32ND AVENUE
AT THE AURORA HIGHLANDS
SITE PLAN

COVER SHEET

DATE: JUNE 1, 2022

SITE PLAN LOT TRACKING EXHIBIT

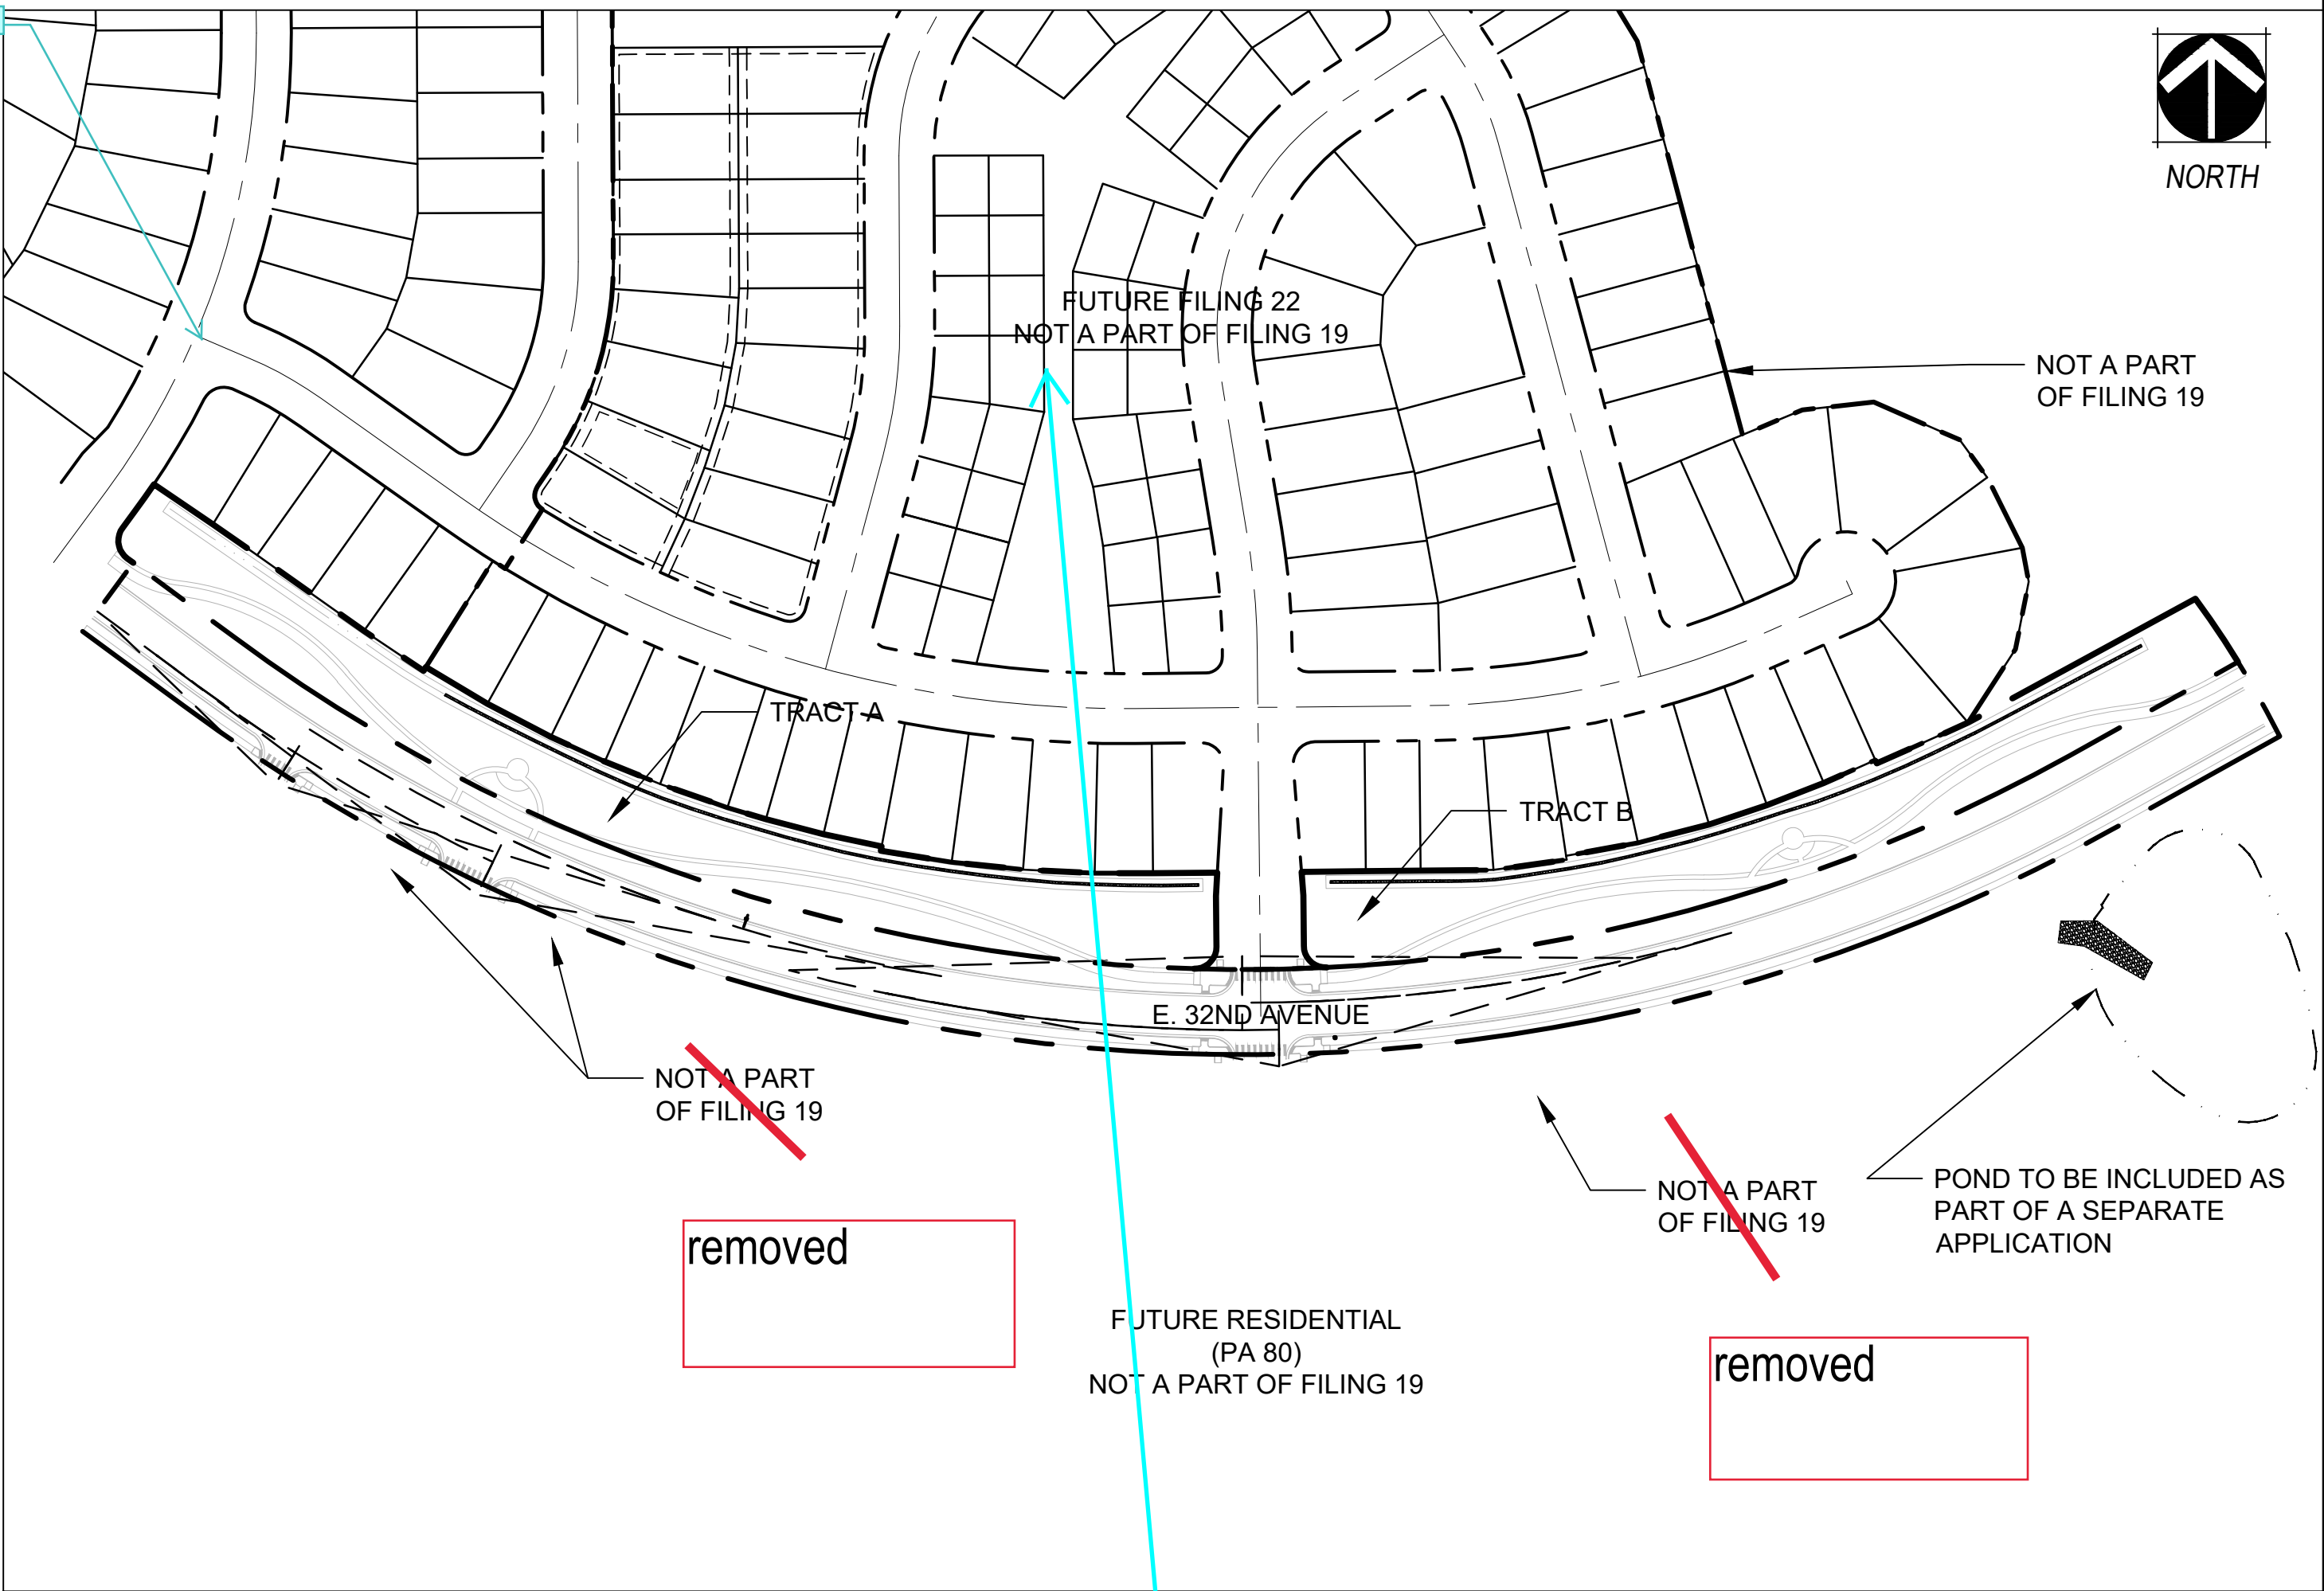
Remove. Do not show lots not in review.

Street label not provided because of comment asking for these lots to be removed

SHEET: 08 OF 22

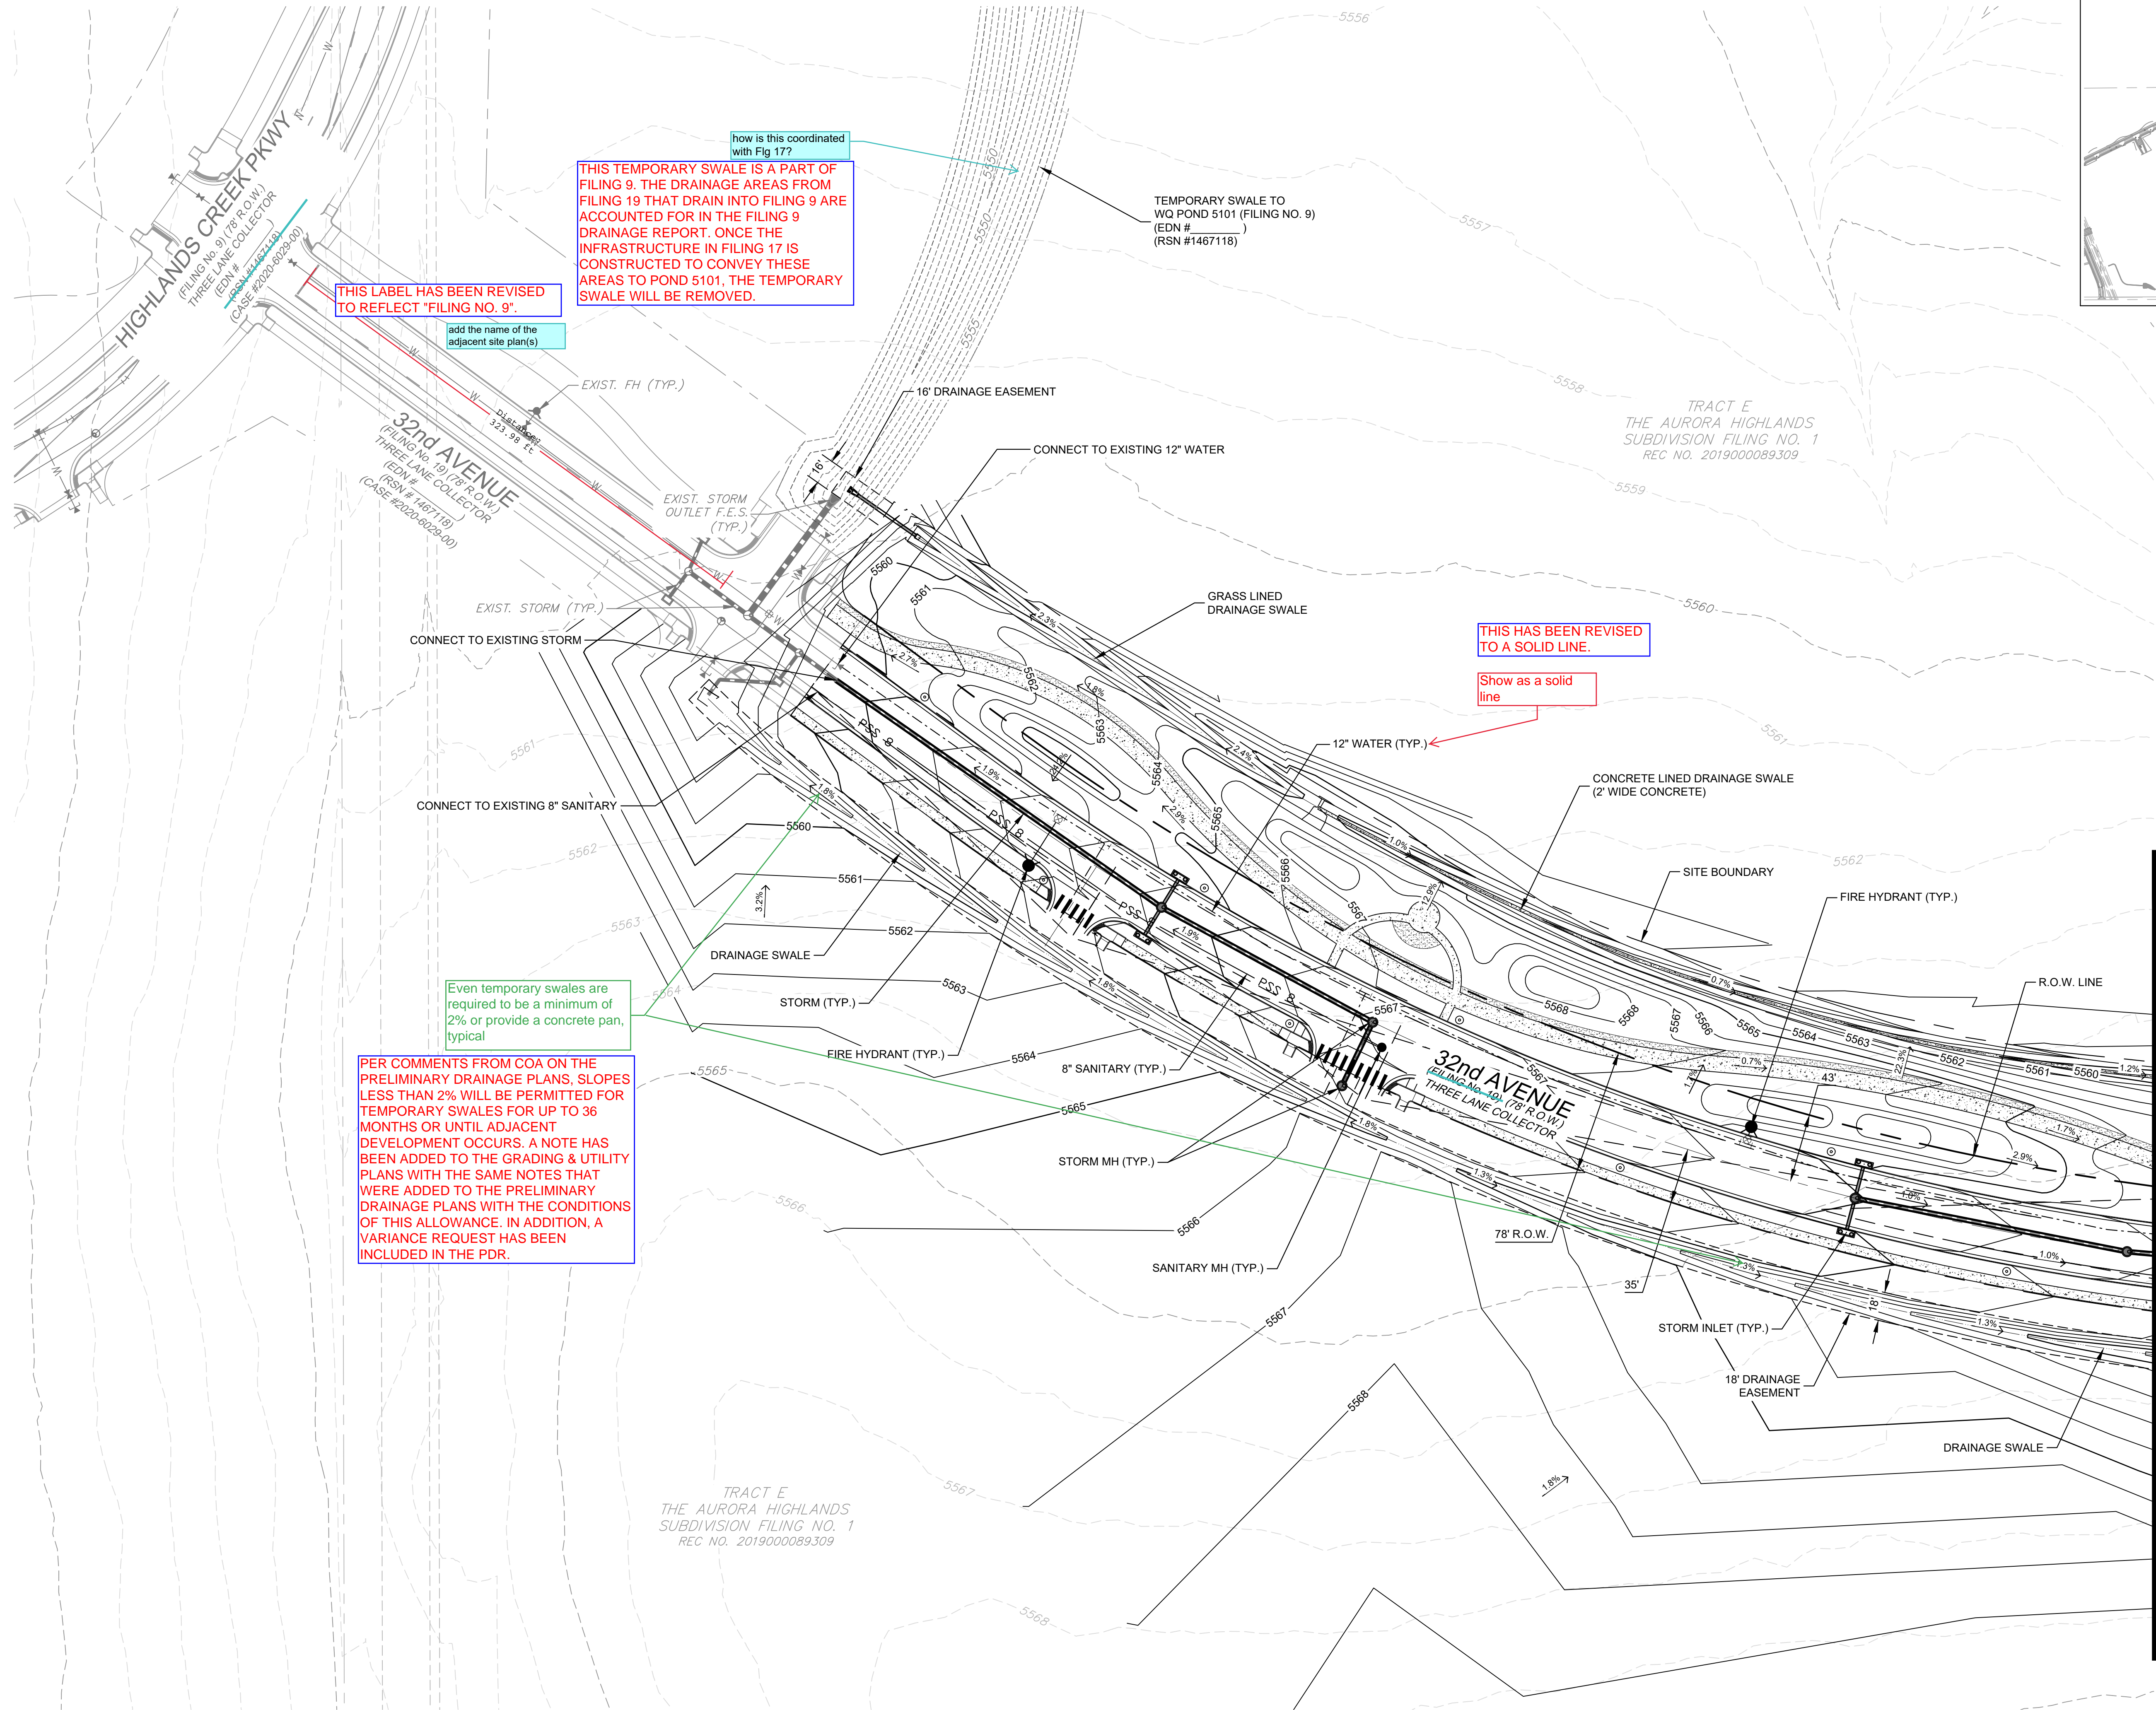
add the name of the adjacent site plan(s)

Show as a solid line

Even temporary swales are required to be a minimum of 2% or provide a concrete pan, typical

THIS LABEL HAS BEEN REVISED TO REFLECT "FILING NO. 9".

THIS HAS BEEN REVISED TO A SOLID LINE.

PER COMMENTS FROM COA ON THE PRELIMINARY DRAINAGE PLANS, SLOPES LESS THAN 2% WILL BE PERMITTED FOR TEMPORARY SWALES FOR UP TO 36 MONTHS OR UNTIL ADJACENT DEVELOPMENT OCCURS. A NOTE HAS BEEN ADDED TO THE GRADING & UTILITY PLANS WITH THE SAME NOTES THAT WERE ADDED TO THE PRELIMINARY DRAINAGE PLANS WITH THE CONDITIONS OF THIS ALLOWANCE. IN ADDITION, A VARIANCE REQUEST HAS BEEN INCLUDED IN THE PDR.

SHEET: 10 OF 22

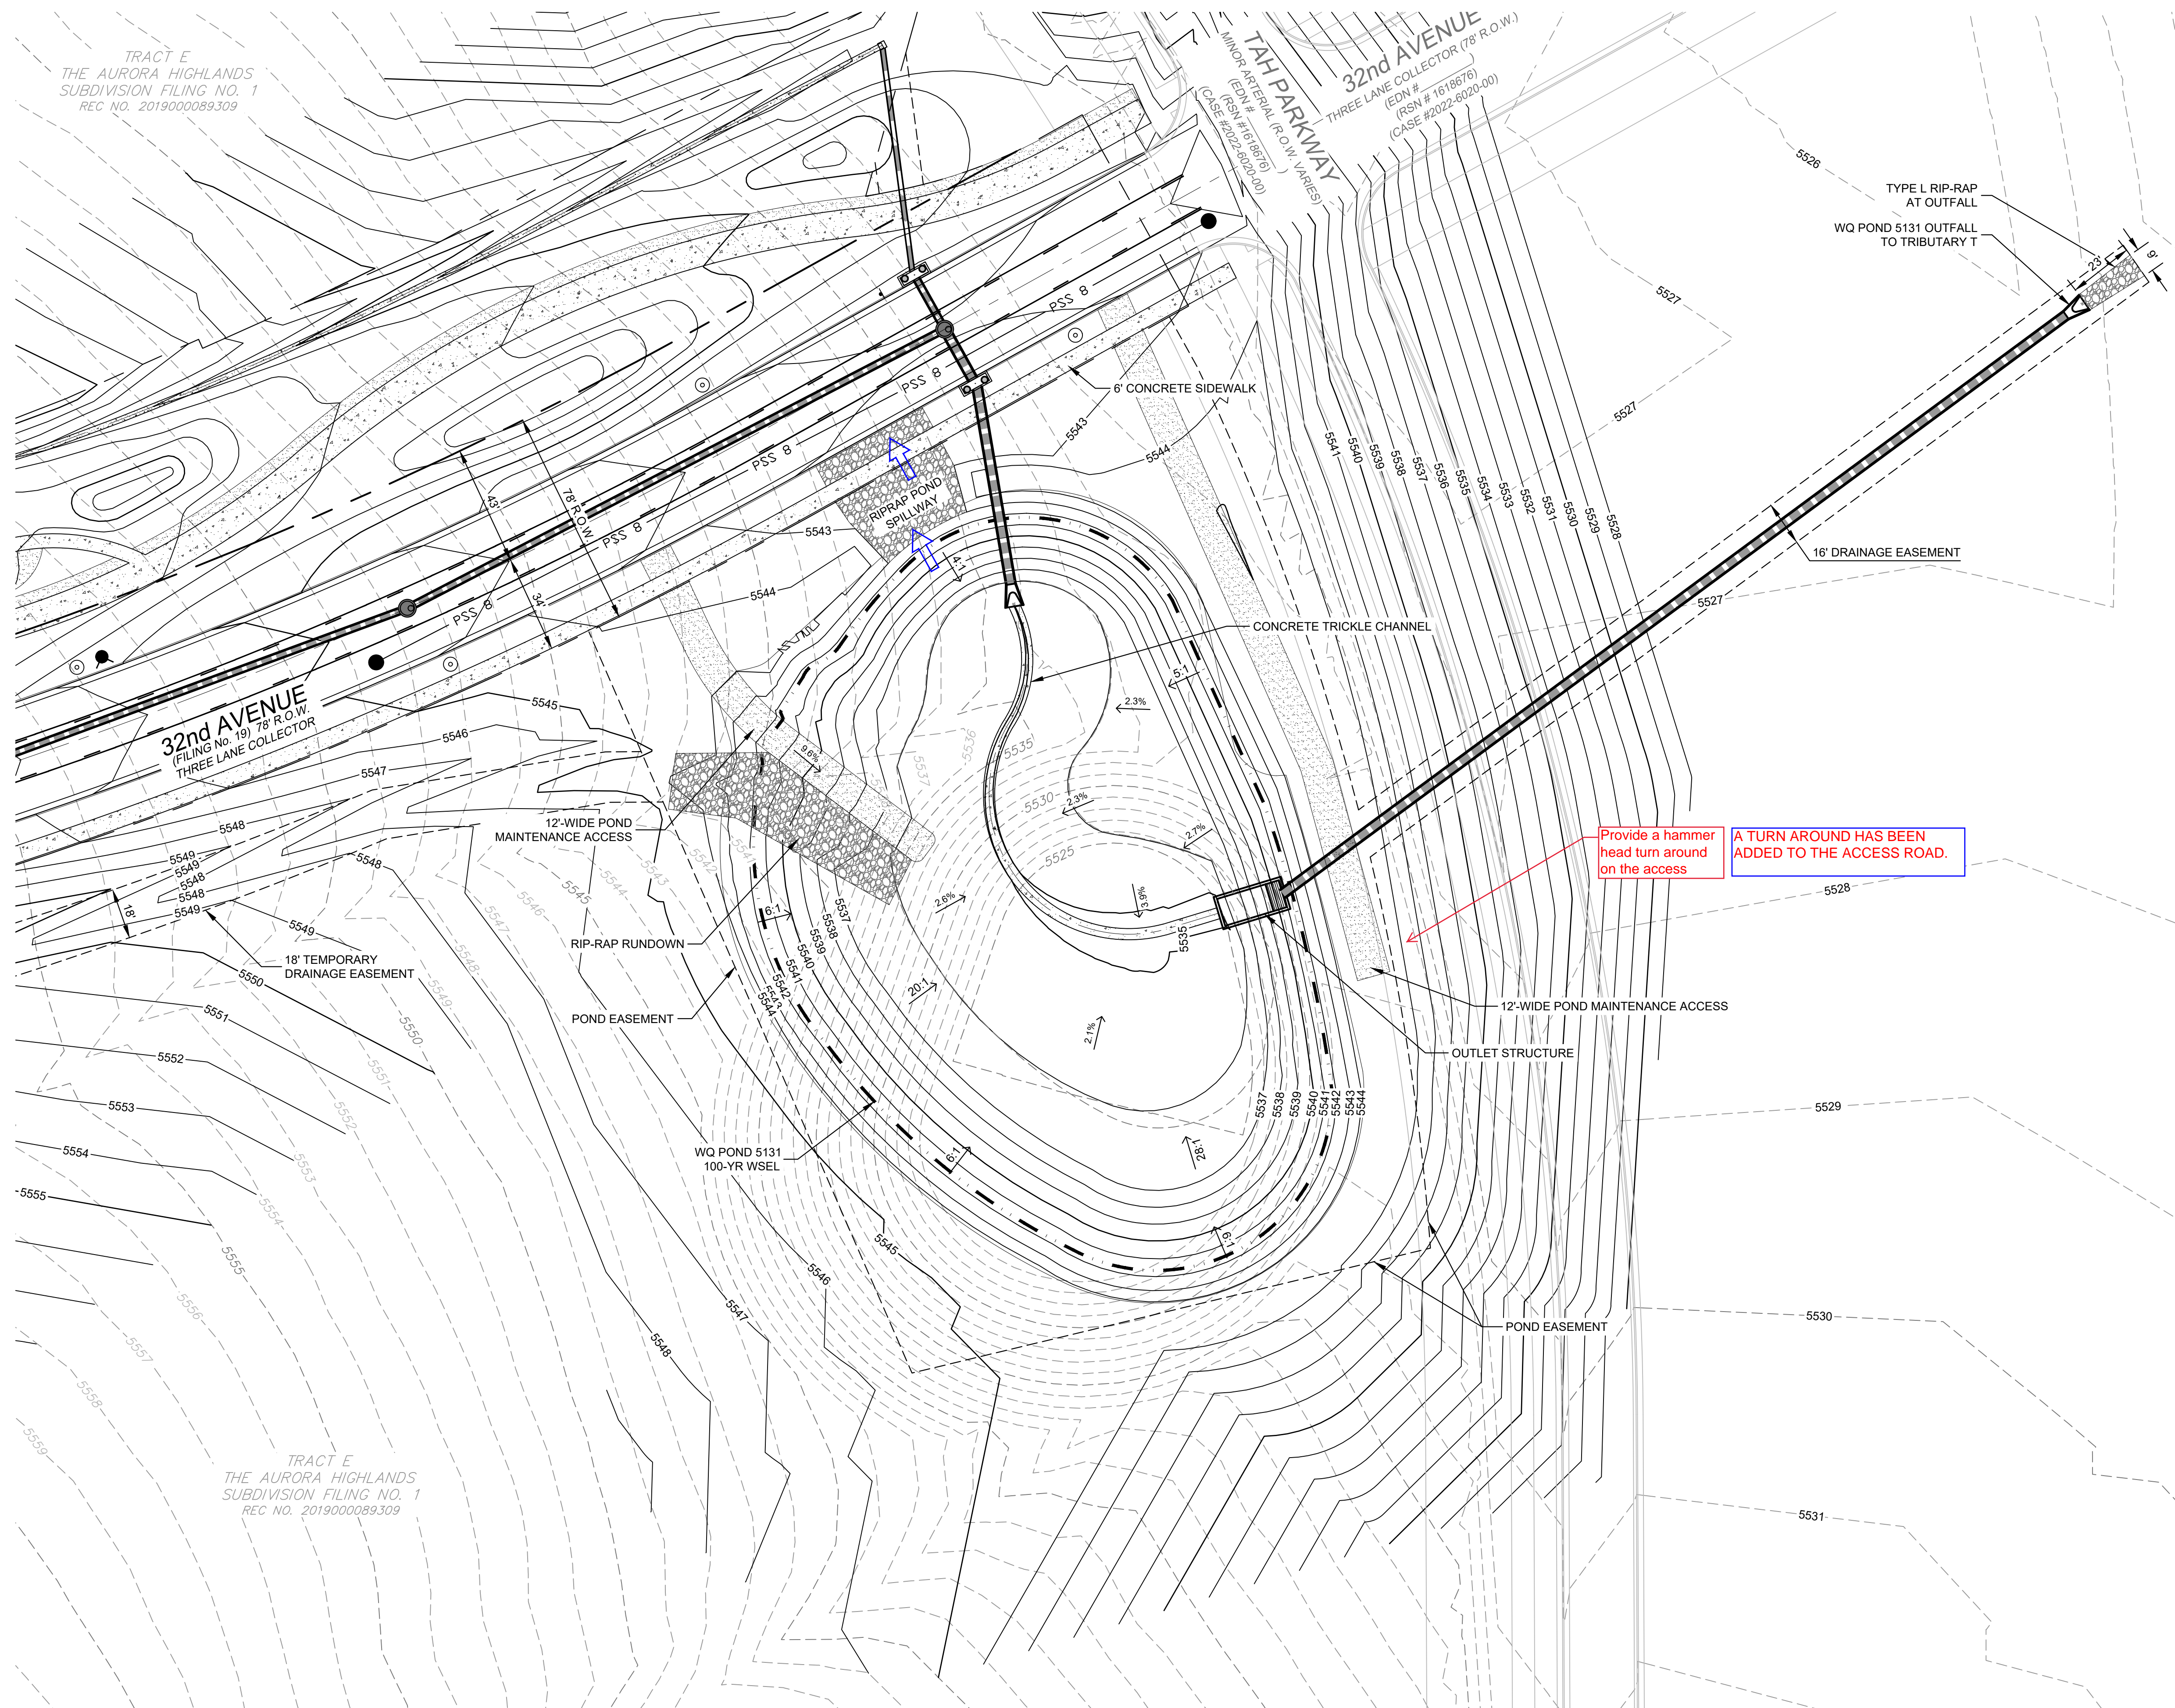
Even temporary swales are required to be a minimum of 2% or provide a concrete pan, typical

PER COMMENTS FROM COA ON THE PRELIMINARY DRAINAGE PLANS, SLOPES LESS THAN 2% WILL BE PERMITTED FOR TEMPORARY SWALES FOR UP TO 36 MONTHS OR UNTIL ADJACENT DEVELOPMENT OCCURS. A NOTE HAS BEEN ADDED TO THE GRADING & UTILITY PLANS WITH THE SAME NOTES THAT WERE ADDED TO THE PRELIMINARY DRAINAGE PLANS WITH THE CONDITIONS OF THIS ALLOWANCE. IN ADDITION, A VARIANCE REQUEST HAS BEEN INCLUDED IN THE PDR.
